**Amendments to the Drawings**

Application No. 10/010,894  
Amendment dated September 24, 2003  
Supplemental Preliminary Amendment  
Replacement Sheet

Fig. 1

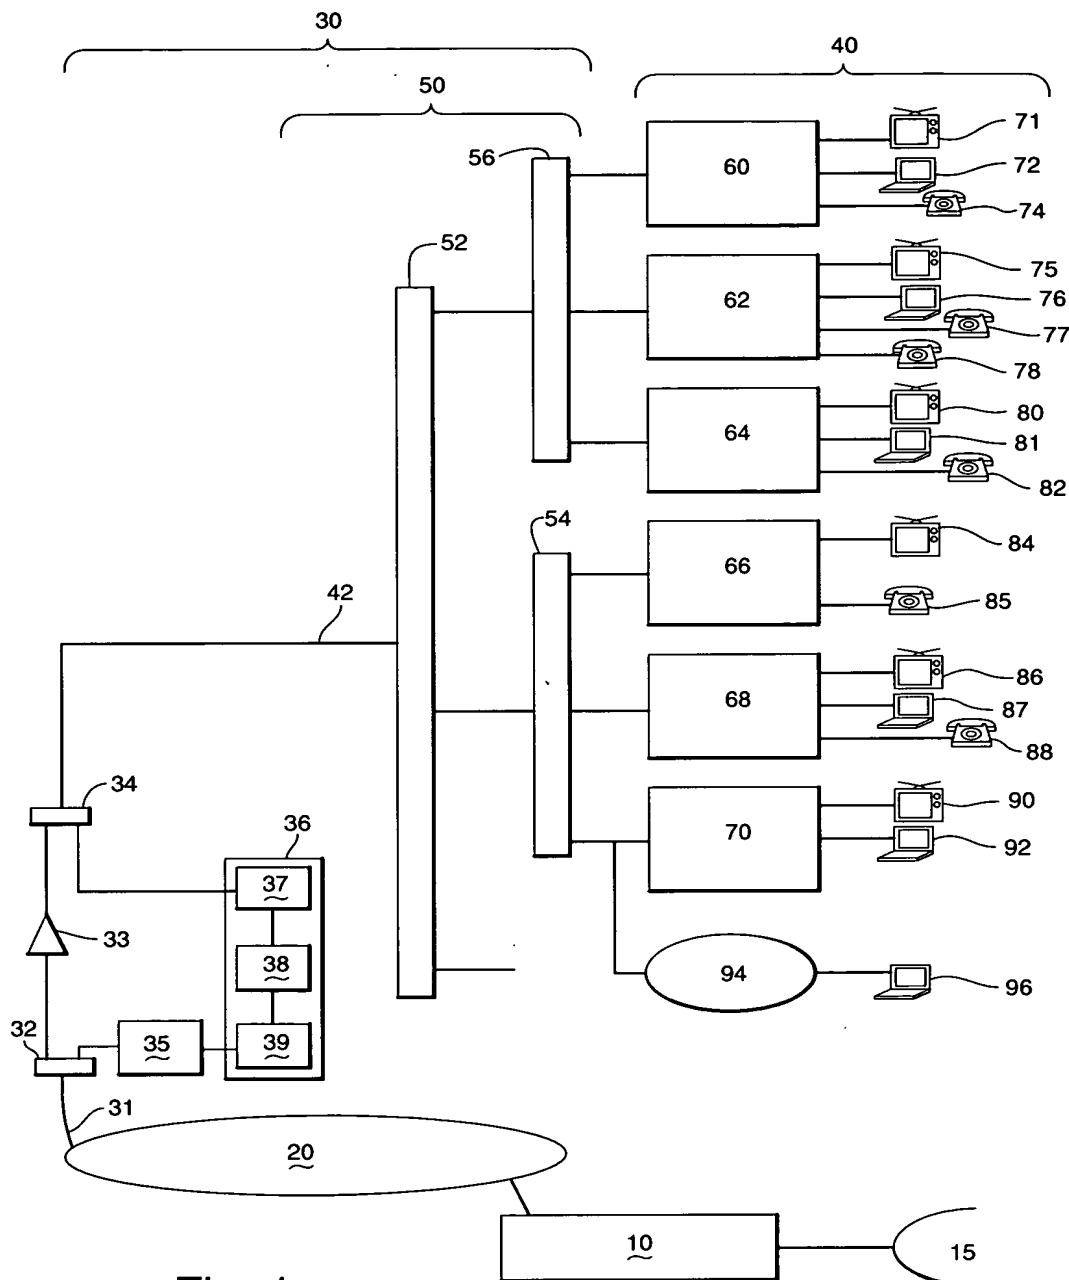
Figure 1 has been updated to remove informalities and the word Figure has been changed to Fig.

Fig. 2

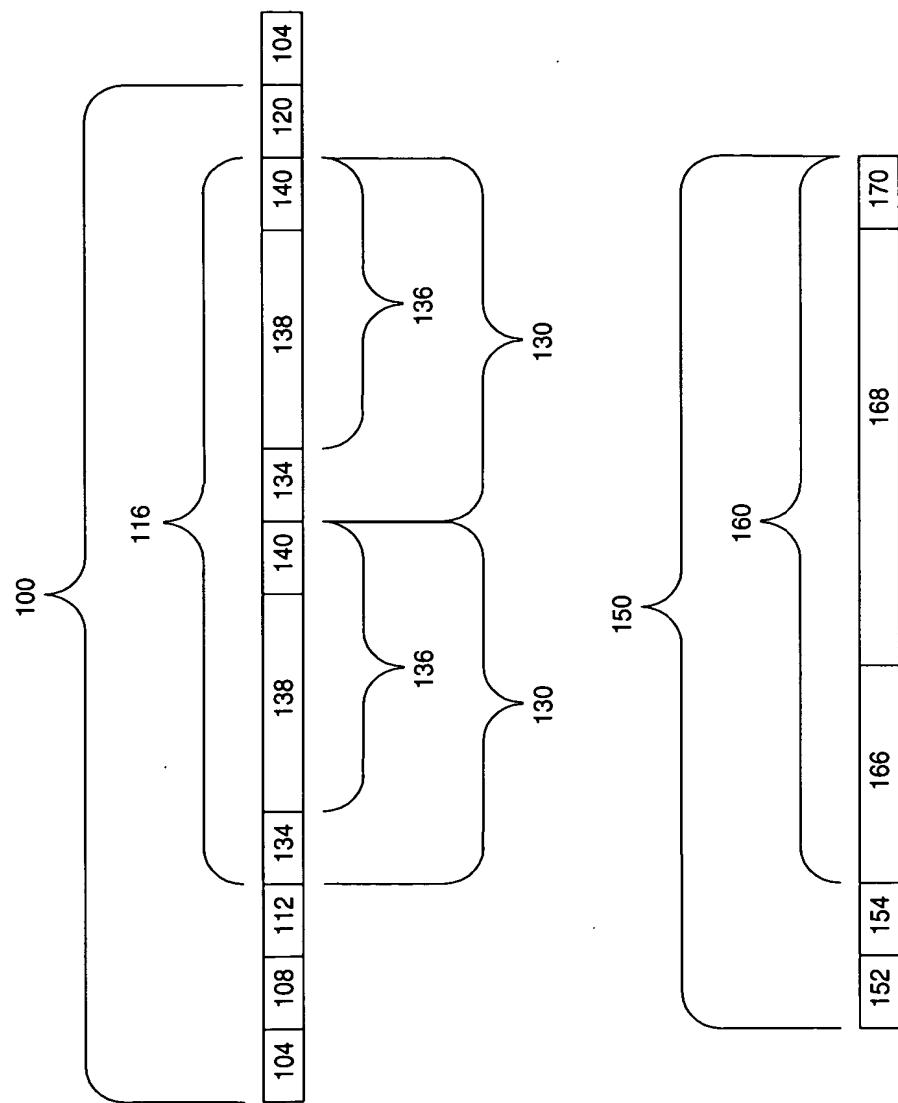
Figure 2 has been modified to remove idle periods 180 and the second instance of 152 as these elements were not necessary in order to illustrate an example of an upstream transmission frame 150. Element 170 has been modified to make it consistent with other portions of upstream transmission frame 150. None of these changes add new matter.

Fig. 3

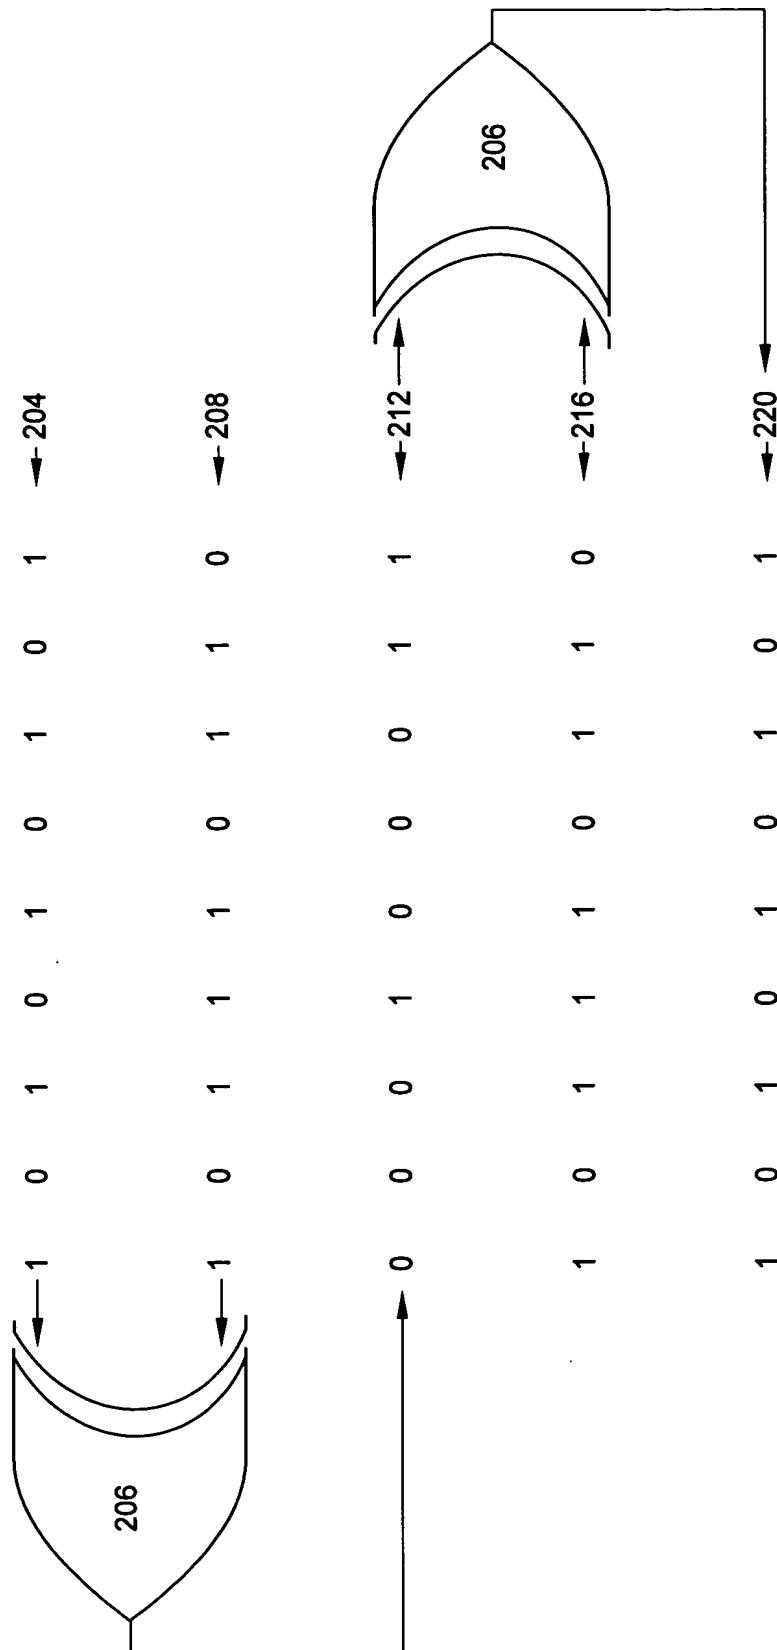
Figure 3 has been modified to better show that function 206 is an exclusive OR (XOR) function. This drawing change is in keeping with the relevant text of the original specification:
